INTERIM CHANGE REQUEST

Plan Title/Rev. Unit 1 Inservice Inspection Plan Rev 5 ICR No. ISI-IR5-01

Reason for Change: Implementation of the IRFO6 ISI Outage Plan has identified several examination items that have been corrected, have had calibration block changes, have been rescheduled or require relief requests. The changes requested maintain ISF Plan compliance with ASME Section XI requirements for sample percentages, schedules and examination methods.

COMPONENT ID TBX-1-1300-1

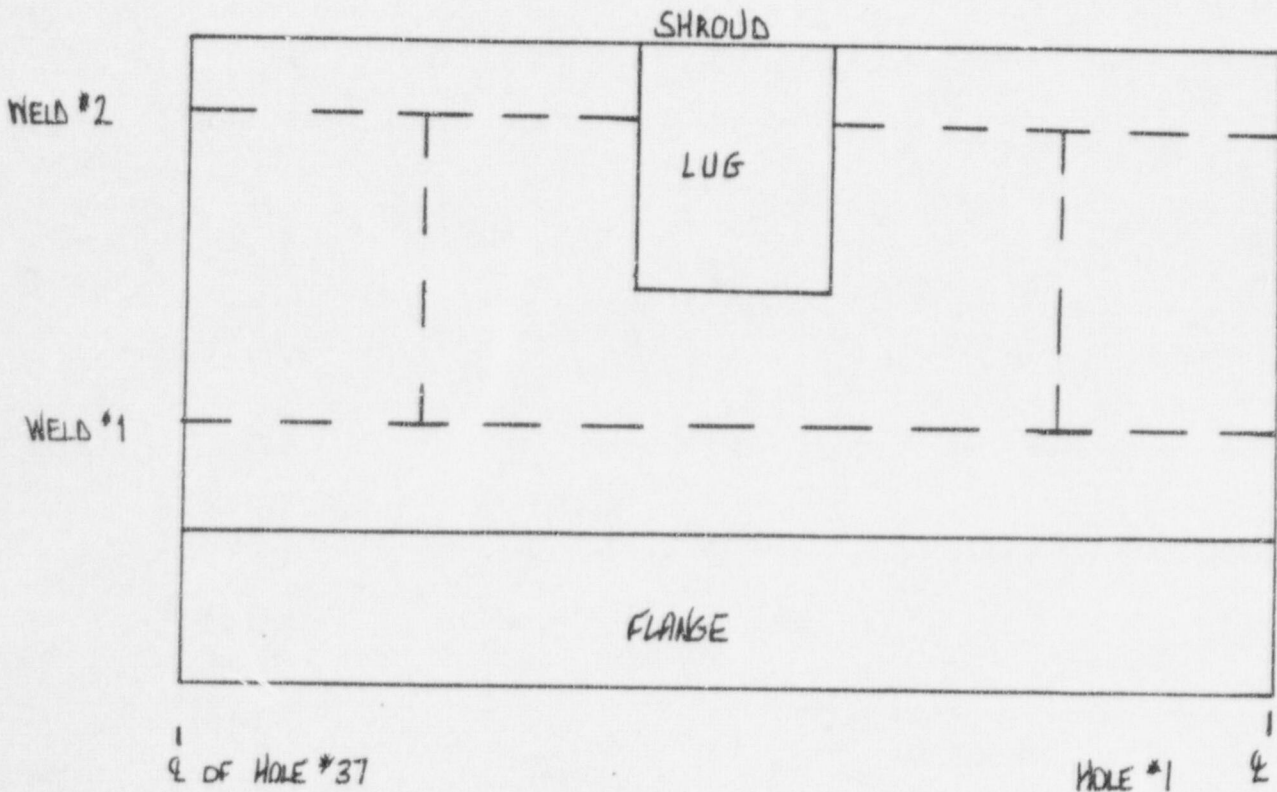
LIMITATIONS ARE DUE TO FLANGE, SHROUD AND LIFTING LUG. SEE WELD PROFILE OBTAINED AT 1RF01 FOR EXAMINATION COVERAGE PLOT.

PLANT COMANCHE PEAK UNIT 1 SKETCH TBX-1-3100 Rev. 1
 SYST/COMP STEAM GENERATORS PROCEDURE TX-151-210 Rev. 2
 EXAMINER Amel A. B. H. in Level B Leany m/Volkman N/Olin & Kelly DATE 11-6-93

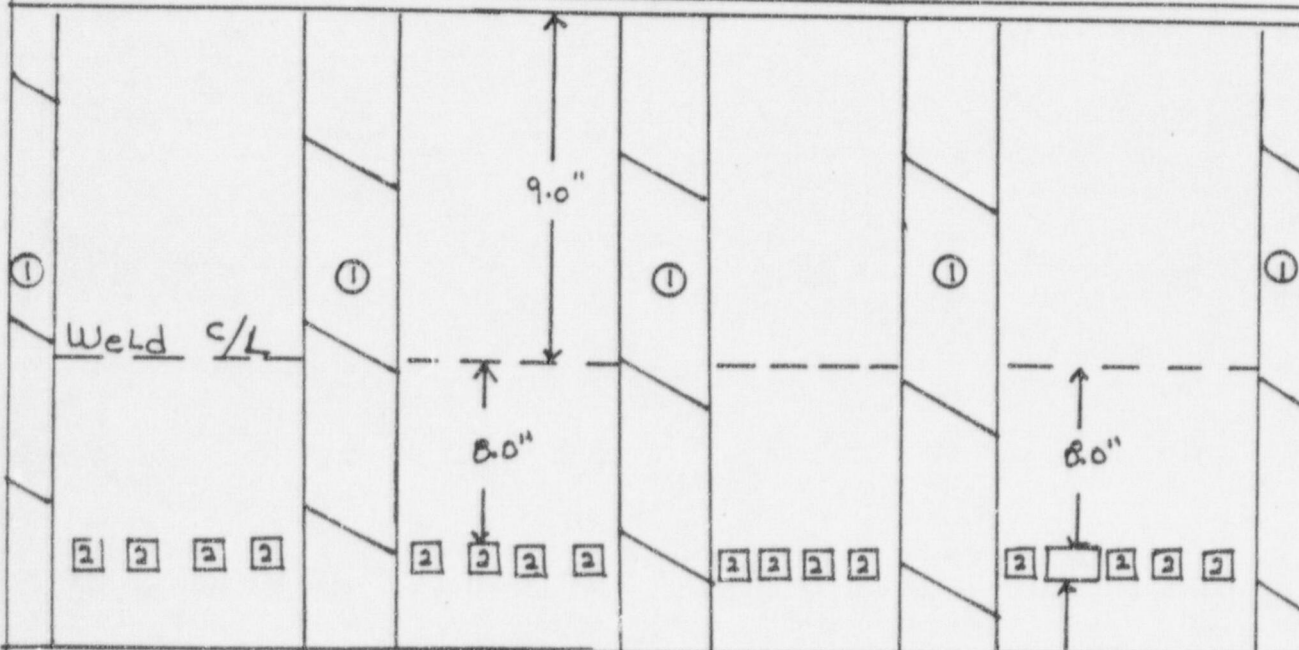
- ① 4ea. 2'x2' Generator Supports @ 2.5" APART 360° Around Weld
- ② 2.5" x 2.5" INSULATION PADS, 19" APART 360° AROUND WELD
- 6.5" x 3.5" I. D. TAG, 28" FROM 0° REFERENCE

Note 20.9% of Required Volume Not Examined Due to The Above Limitations

COMPONENT ID TBX-1-2100-1

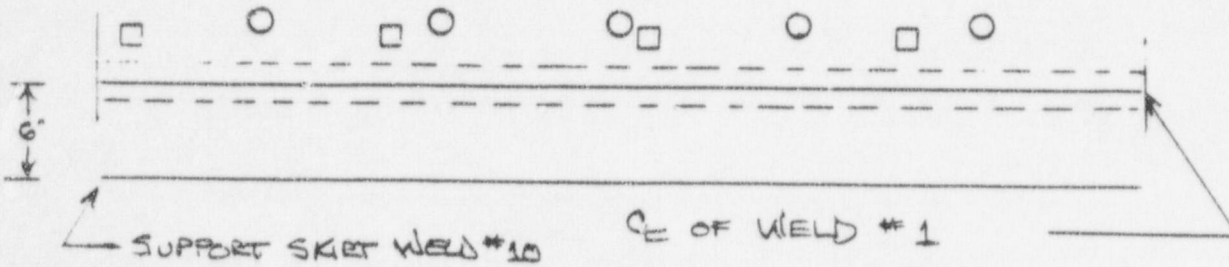
The specific examination area geometry of the lower head to shell weld and interferences from instrumentation lines, welded pads and the support skirt preclude the complete ultrasonic examination of the volume required by Fig. IWB-2500-1 for weld TBX-1-2100-1. Approximately 16% of the volume did not receive the full code required coverage. Best effort examinations were performed. Full circumferential scan coverage was obtained. Axial scan coverage was achieved for approximately 97% of the required volume in at least one beam path direction with one angle.

COMPONENT ID TBX-2-1110-1

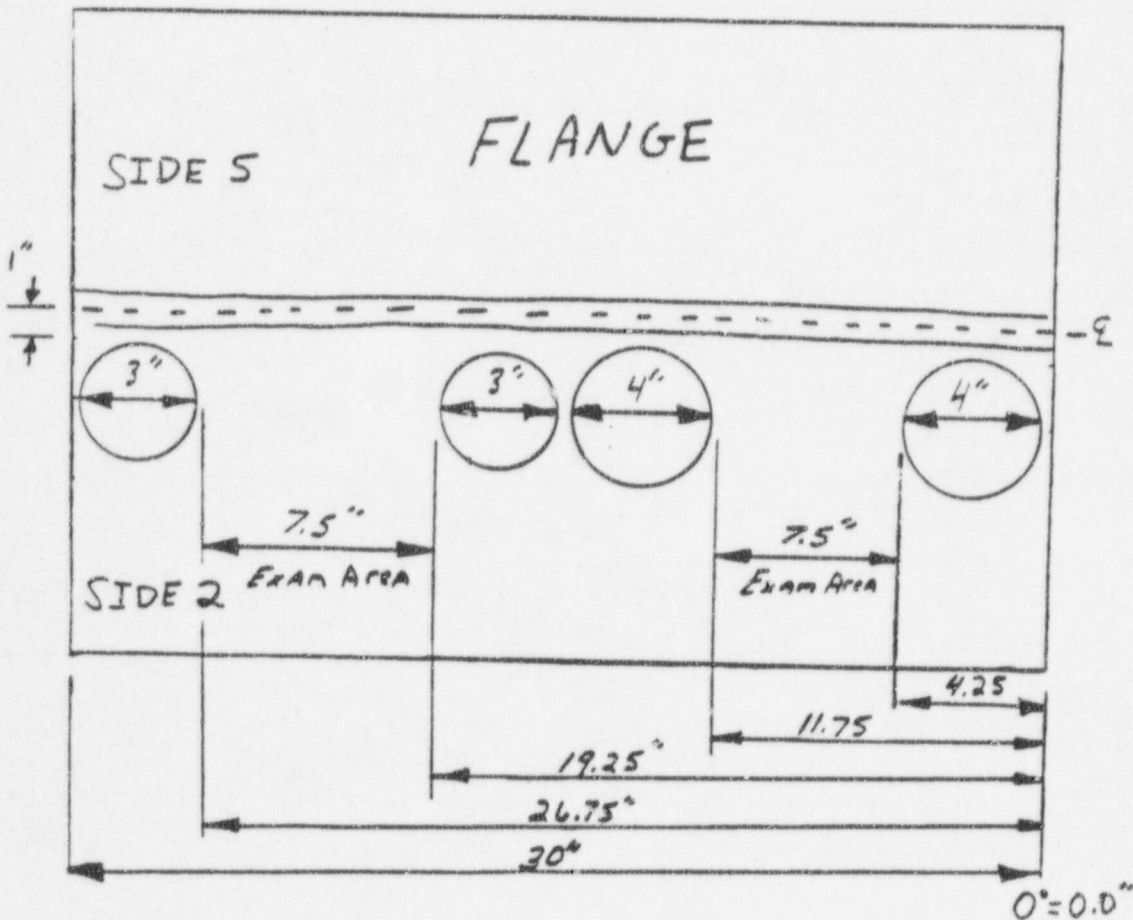
For weld TBX-2-1110-1, interferences from the heat exchanger inlet, outlet and instrumentation nozzles and from the flange taper preclude the complete ultrasonic examination of the volume required by Fig. IWC-2500-1. Approximately 50% of the weld length did not receive the full code required examination coverage. See pages 2 through 4 for weld location and examination area configuration for weld TBX-2-1110-1.

COMPONENT ID TBX-2-1180-2-2

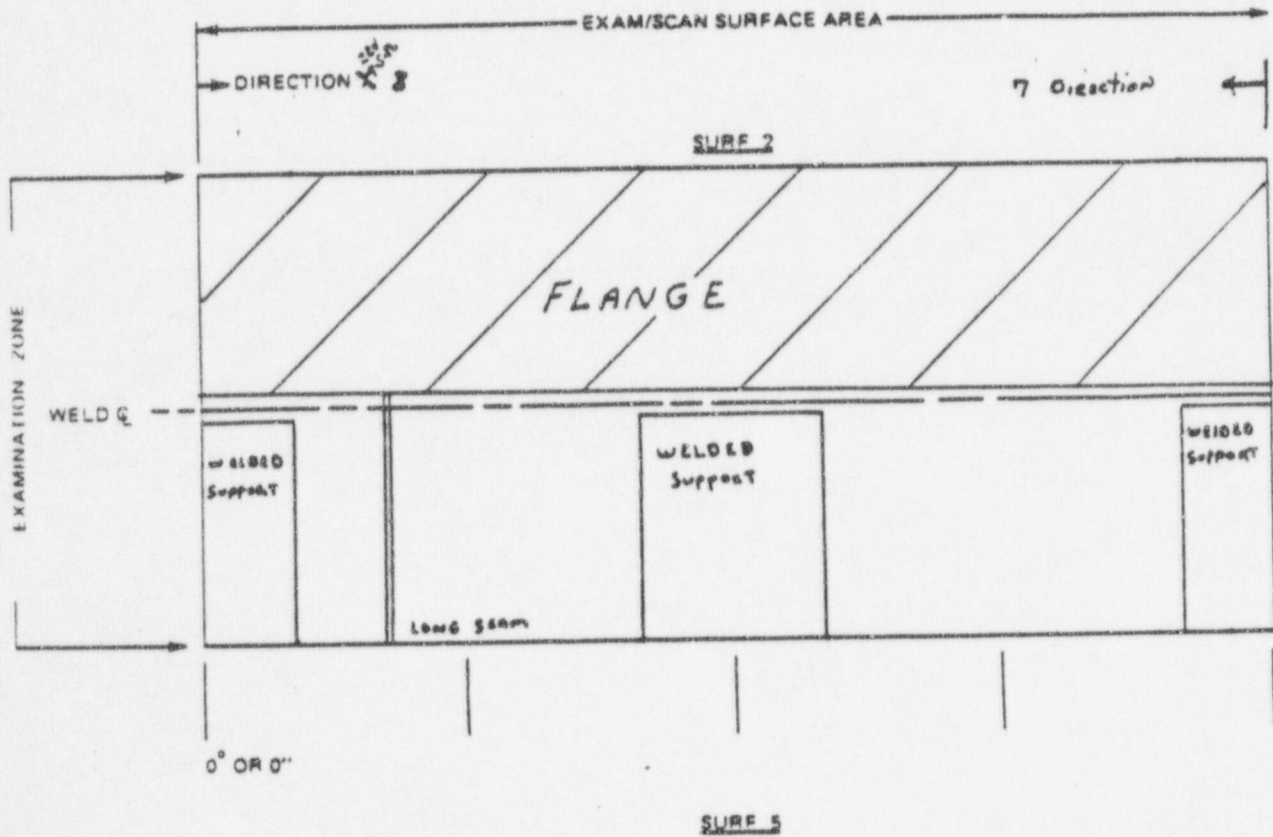
For weld TBX-2-1180-2-2, interferences from the heat exchanger welded support pads preclude the complete ultrasonic examination of the volume required by Fig. IWC-2500-1. Approximately 27% of the weld length did not receive the full code required examination coverage. See pages 5 through 7 for weld location and examination area configuration for weld TBX-2-1180-2-2.
